ADDENDUM NO. 2

San Antonio Water System

Project Name: **Olmos Basin Central Watershed Sewer Relief Line (C-3), Reaches 1 to 4**

Project No.: **08-2512**

D-1 SANITARY SEWER PIPE LAID IN TRENCH

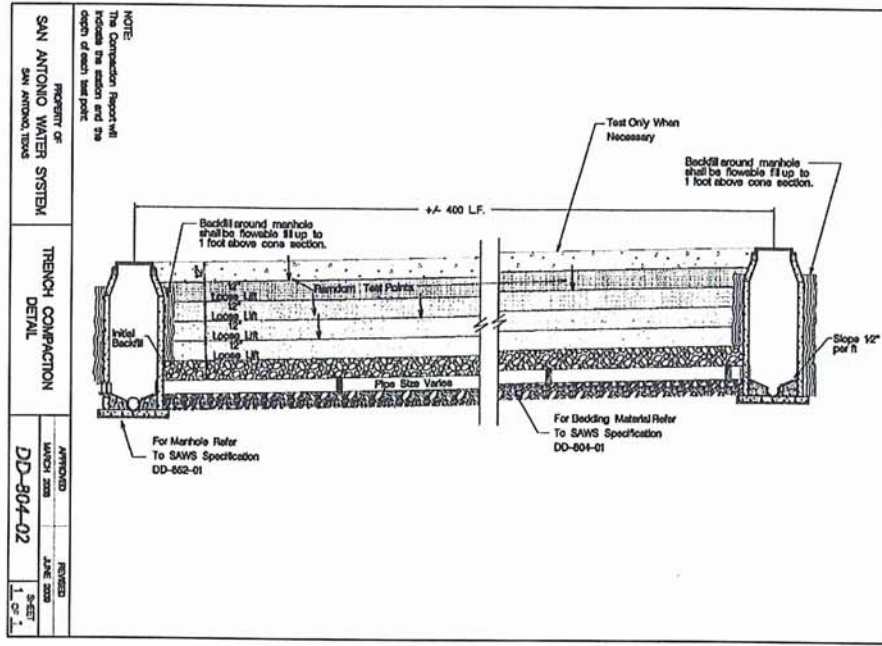
- Item 13: Sheet D-1** – Remove and replace Sheet D-1 with the revised Sheet D-1 attached to this addendum.
Revisions include:
- a) Add note to Detail 1 (Sanitary Sewer Pipe Laid in Trench):
“NOTE: TRENCHES IN PAVED STREETS SHALL BE COVERED WITH A TEMPORARY ALL WEATHER SURFACE TO ALLOW FOR VEHICULAR TRAFFIC UNTIL THE FINAL PAVING IS COMPLETE, INCLUSIVE OF PROVIDING, MAINTAINING, AND REMOVING THE TEMPORARY TRENCH REPAIR PAVEMENT.
REFER ALSO TO SAWS STANDARD SPECIFICATION ITEM NO. 804, PARAGRAPH 804.4.2.d,”

NOTE: TRENCHES IN PAVED STREETS SHALL BE COVERED WITH A TEMPORARY ALL WEATHER SURFACE TO ALLOW FOR VEHICULAR TRAFFIC UNTIL THE FINAL PAVING IS COMPLETE. INCLUSIVE OF PROVIDING, MAINTAINING, AND REMOVING THE TEMPORARY TRENCH REPAIR PAVEMENT. REFER ALSO TO SAWS STANDARD SPECIFICATION ITEM NO. 804, PARAGRAPH 804.4.2.d.
